STANDARD REPAIR DETAIL TO MODIFY TRUSS FROM TOP CHORD BEARING TO BOTTOM CHORD BEARING

MII-REP04

MiTek USA, Inc. Page 1 of 1

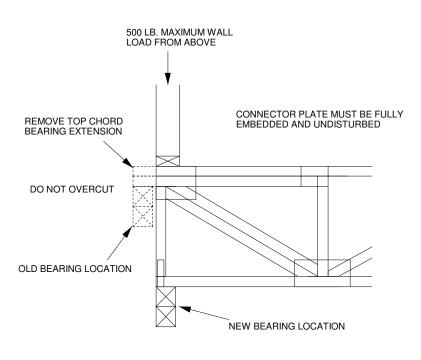
TRUSS BEFORE MODIFICATION:

MODIFIED BEARING CONDITION:

1. THIS IS A SPECIFIC DETAIL TO BE USED ONLY FOR ITS ORIGINAL INTENTION OF PERMITTING THE REMOVAL OF THE TOP CHORD EXTENSION. THIS DETAIL REQUIRES THAT THE REMAINING PORTION OF THE TRUSS IS UNDAMAGED.

- 2. CUT OFF TOP CHORD EXTENSION WITHOUT DAMAGING OR CUTTING THE EXISTING PLATES.
- 3. NO OTHER MODIFICATIONS ARE PERMITTED.
